# **POWER AND WATER CORPORATION'S PROPOSED AMENDMENTS TO CODES - GENERATOR PERFORMANCE STANDARDS**

**DRAFT DECISION**

*4 December 2019*

The purpose of this paper is to communicate the Utilities Commission's (commission) Draft Decision on the Power and Water Corporation's (PWC) application to the commission to approve proposed amendments to the Network Technical Code (NTC) and System Control Technical Code (SCTC).

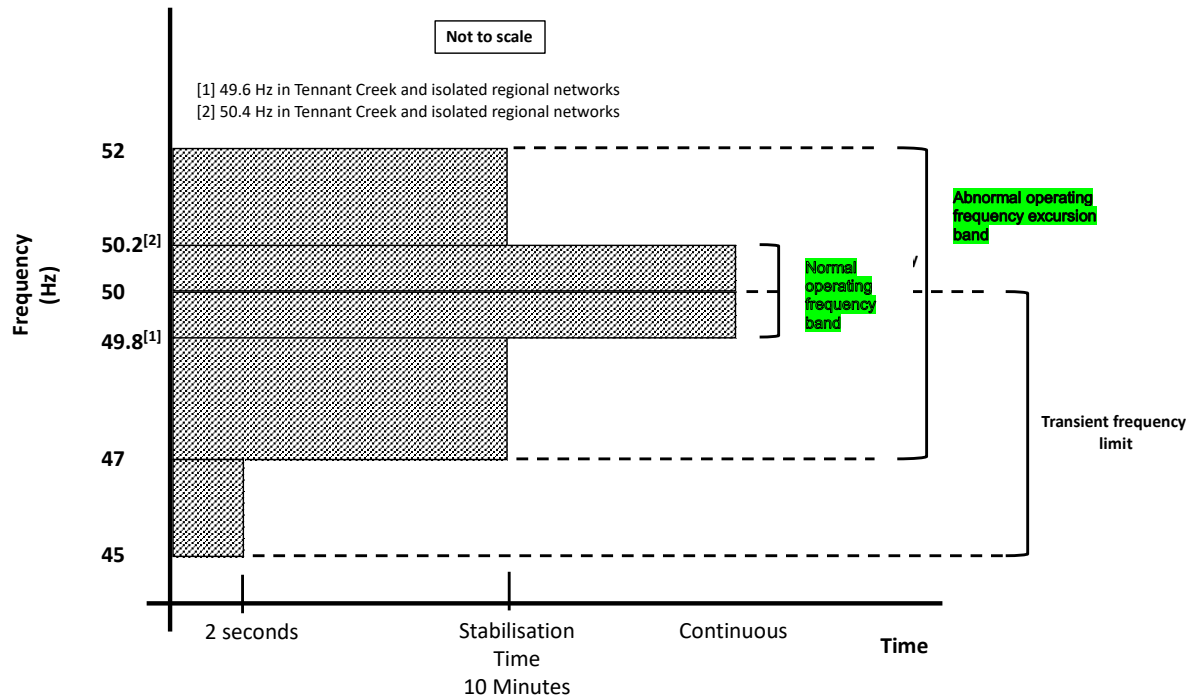
- stabilisation time is not defined in the frequency operating standard which according to the glossary is defined in clauses 2.2 and 2.4 on the NTC. The definition of stabilisation time should be amended to clarify that it is 10 minutes.
- RoCoF (rate-of-change-of-frequency) is not specified with any time dimension making the requirement more onerous than the automatic access standard specified in the NER NT, noting this standard is not currently in effect (the NER NT automatic requirement specifies generators ride through RoCoF of +/- 4Hz/s for 0.25s and +/- 3Hz/s for 1s).

that the synchronous generators connected to Territory power systems have demonstrated an ability to ride through relatively high RoCoF events and furthermore at a RoCoF of 4Hz/s, the limits of the frequency ride-through bands specified in NTC clause 3.3.5.3 are reached quickly. PWC have therefore suggested that specifying a time dimension for RoCoF performance is not necessary. GHD has advised the commission that there is merit in PWC's argument and that it does not recommend any change to the RoCoF provisions proposed by PWC. The commission accepts GHD's view.

**stabilisation time** means the longest times allowable for the *frequency* of the *power system* to remain outside the normal operating frequency band, for any condition (including an "island" condition) in the *frequency operating standards* that apply to the *region* in which the *generating unit* is located. **The stabilisation time is 10 minutes.**

**transient frequency limit and transient frequency time** mean the values of 45 Hz and 2 seconds respectively, or such other values determined by the *Power System Controller*.

**Figure 9 – Inertia vs C-FCAS Trade Off Requirements for New Generators**

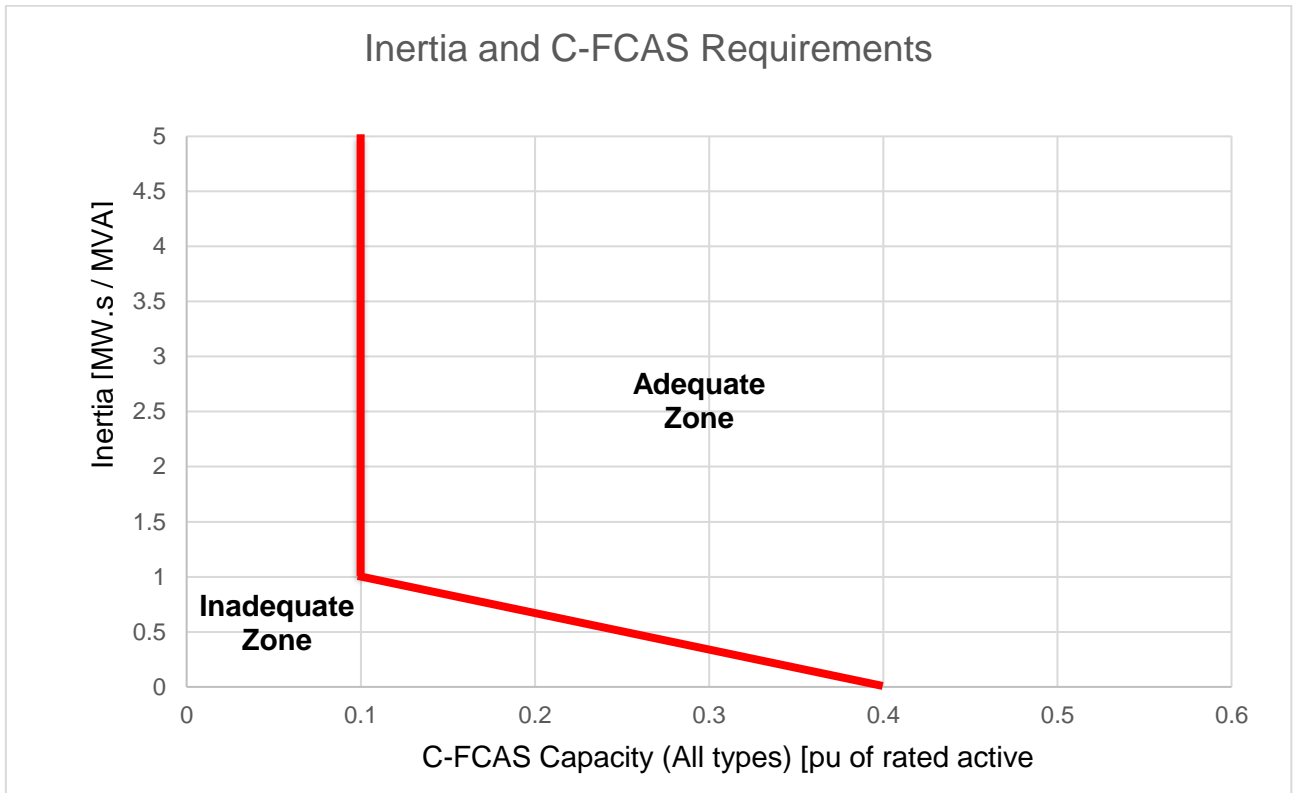
- (2) *Inertia* offered or provided from non-synchronous (emulated) sources needs to be assessed and accepted by the *Power System Controller* and *Network Operator*.

- (3) The *inertia* and *FCAS* capabilities will be accredited by the *Power System Controller* using the specifications and evaluation framework outlined in the System Secure Guidelines.

Figure 6.5: Forecasting accuracy, worst error

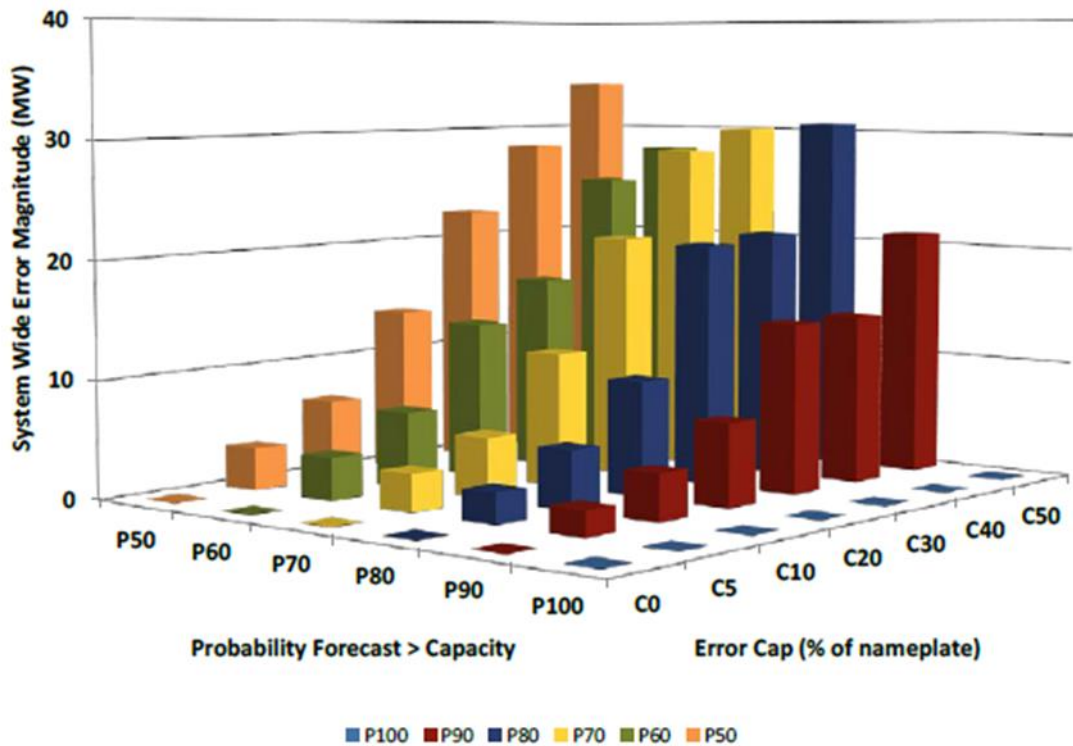
Figure 6.5 shows the system wide error that was simulated for different levels of solar forecast accuracy.

The proposed accuracy standard would deliver 90% of periods where forecast capacity is less than the actual capacity and a maximum error of 5% between the forecast and actual solar capacity. Table 2.1 indicates that forecast accuracy is estimated to breach the SSG about 1.5% of the time that solar generators are producing power. Figure 6.5 suggests the specified forecast accuracy will result in a system wide impact of a few MW.

Figure 4 - Power Supply / Demand Mismatch vs System Demand and Unregulated Frequency Impacts

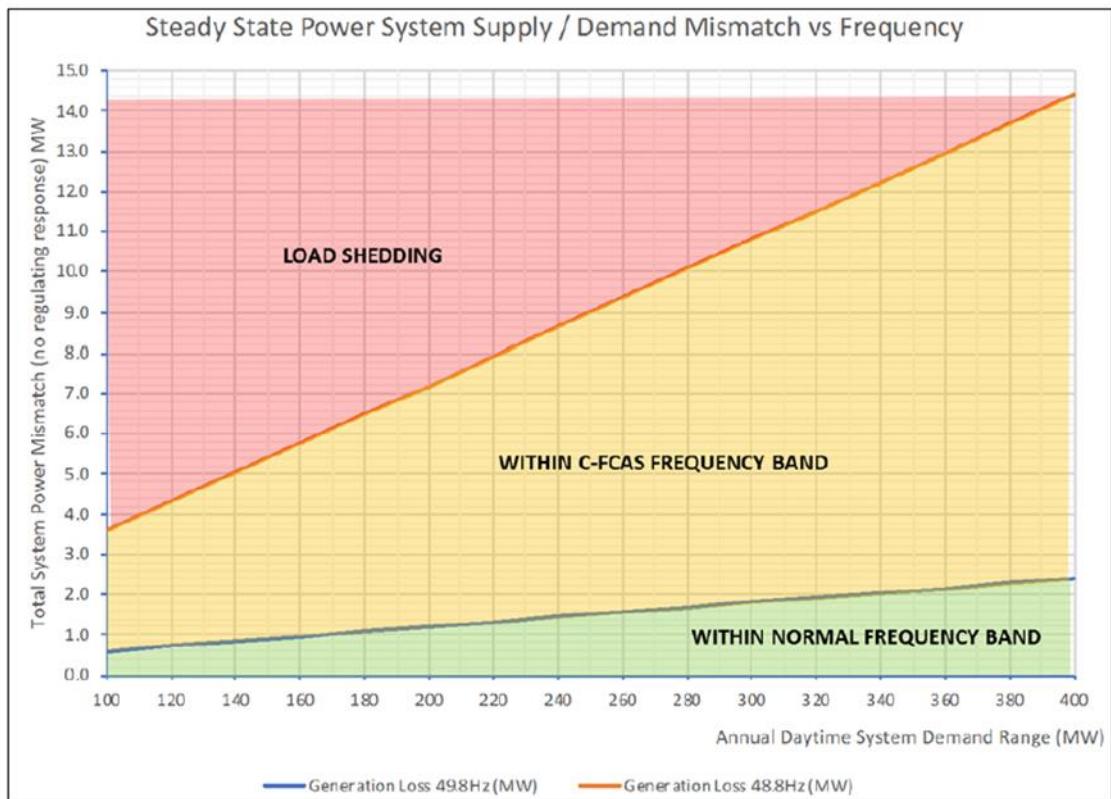
Figure 4 below was extracted from the supplementary consultation paper developed by PWC in March 2019, titled “framework for the future”. The figure presents an analysis of the size of imbalance between load and generation that could breach the frequency operating standard assuming no governor response. It shows that an imbalance of less than 3.75 MW, with no governor response available should not give rise to load shedding. This means that a cloud cover event that causes a net generation reduction of less than 3.75 MW and occurs concurrently with a generator contingency should not give rise to load shedding. 3.75 MW aligns with the level of system wide error shown in Figure 6.5 for a solar forecast accuracy requirement achieving 90% of forecasts below the actual capacity and a maximum forecast error of 5%. This suggests that these accuracy requirements may be appropriate if cloud cover events are likely to align with generator contingencies in the Territory power systems.
